**Edwin I. Hatch Nuclear Plant
Request for License Amendment
Extended Power Uprate Operation**

Page Change Instructions

The proposed changes to the Plant Hatch Unit 1 and Unit 2 Facility Operating Licenses and Technical Specifications are incorporated as follows:

**Facility Operating License Proposed Change
and
Technical Specifications Proposed Changes**

Figure 3.4.9-3 (page 1 of 1)
Pressure/Temperature Limits for Criticality

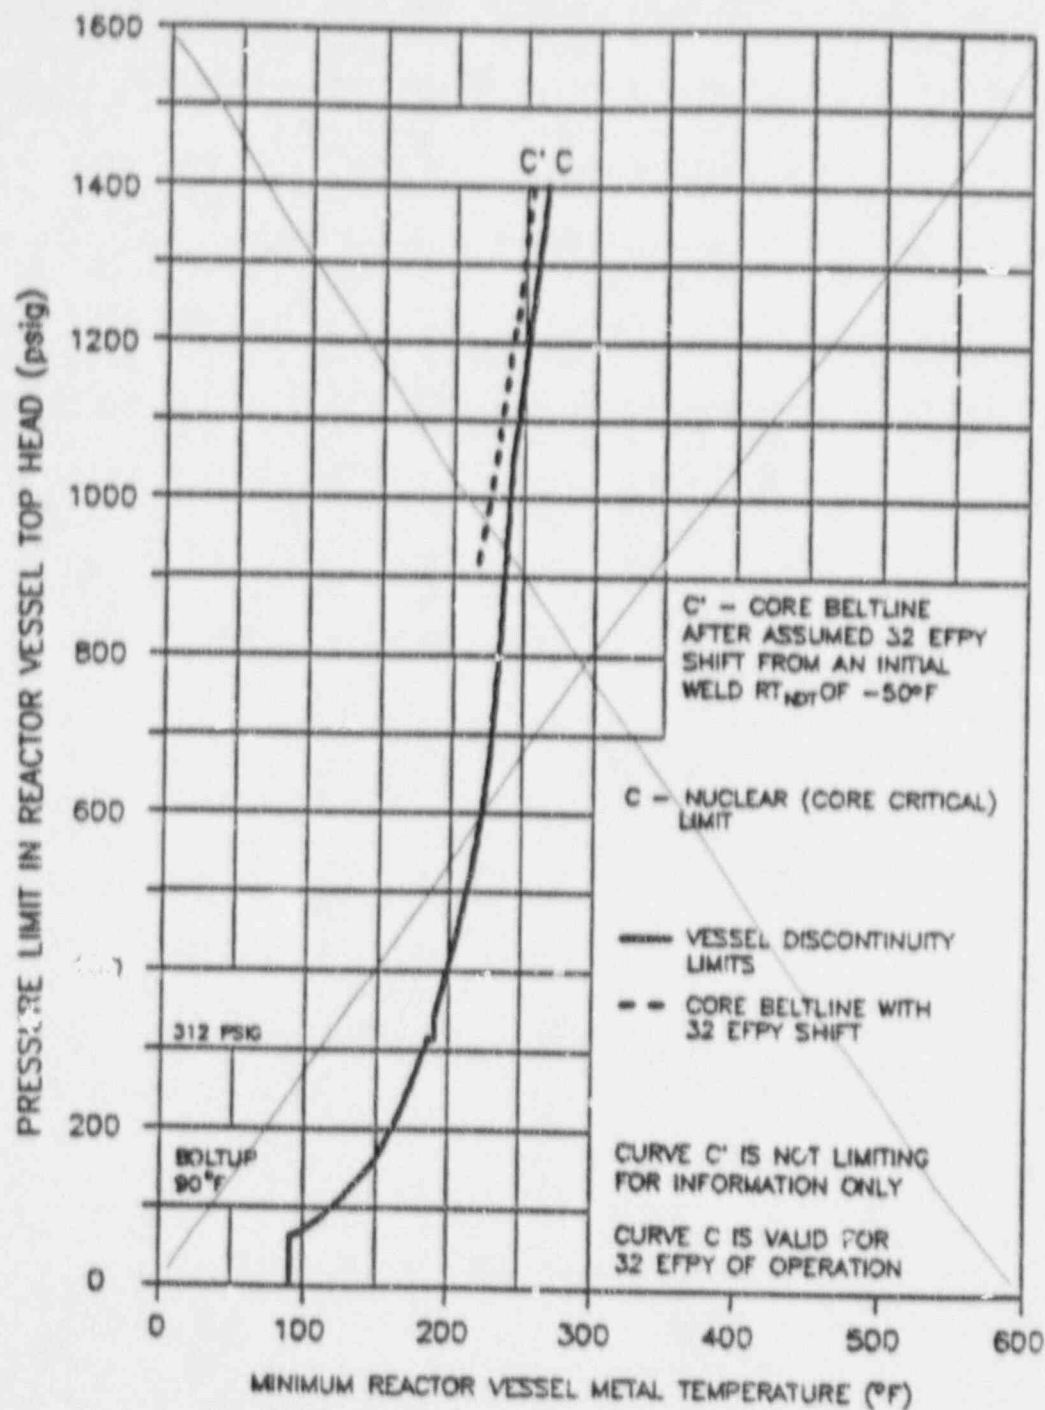
REPLACE WITH C'C CURVE ATTACHED.
